RE: 13886 State Route 108, perc test report

FOR PERCOLATION TESTING AND SITE EVALUATION

SITE INSPECTION SHEET

Proposed SDA on hillside above house

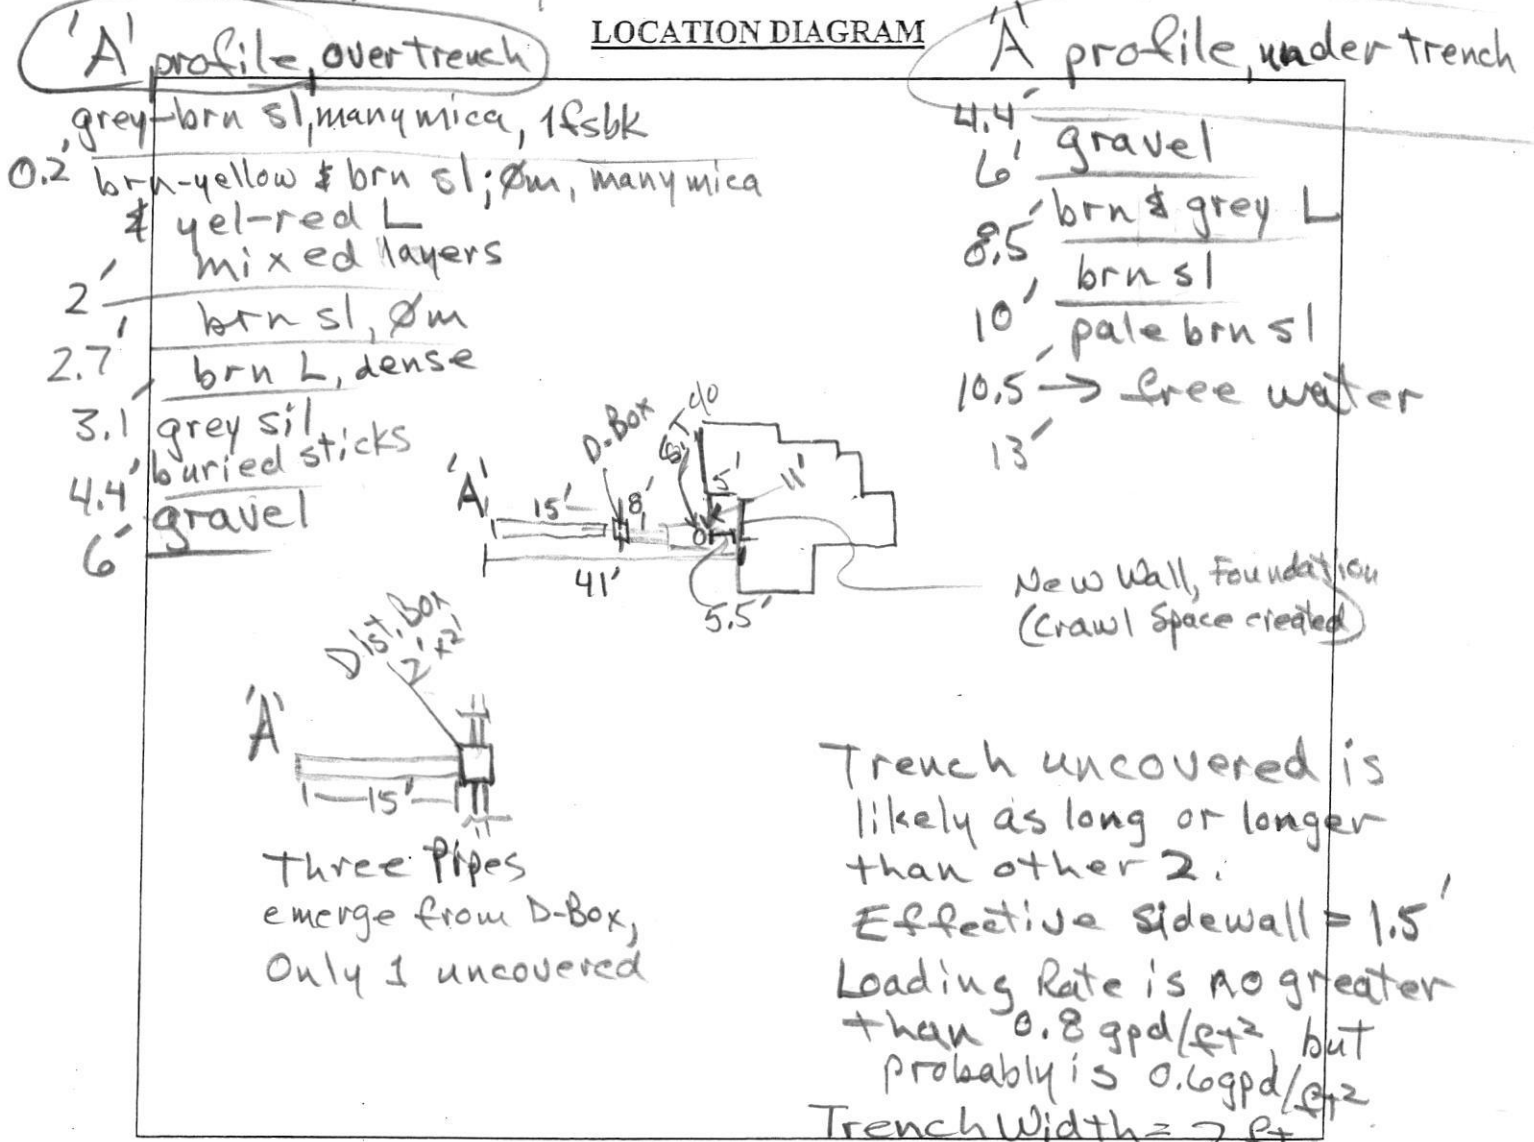
DATE	TEST #	DEPTH	START	BREAK 1" DROP	STOP 2" DROP	TIME OF 2ND INCH	P/F/H
11/26/13	8504	4' 8"	11:40	11:44	11:51	7	P
11/26/13	8501	5' 11"	0	1.4	3.4	2	P
11/26/13	8505	3.1' / 8.5'	12:15	12:30	1:04	34	P*
11/26/13	8503	4.8' / 11.5'	12:32	12:39	12:54	15	P*
11/26/13	8505	8.5'	Visual	3.5' to 4.5'	1.2 gpd / ft		P
11/26/13	8503	11.5'	Visual	4.5' to 7.5'	1.2 gpd / ft		P

REMARKS: 8505, Passed by Sanitarians judgement
 SANITARIAN: R Bricker BACKHOE: Donnie (Hutfields) OTHERS: Jeff Reitor, Omar El Sawi
 TEST HOLES USED IN SDA: _____ AVG. PERC TIME: _____ SQ. FT/BR: _____
 TRENCH WIDTH: _____ INLET DEPTH: _____ MAX. BOT DEPTH: _____ EFFECTIVE SW: _____

* Hard Rain falling throughout Testing Period
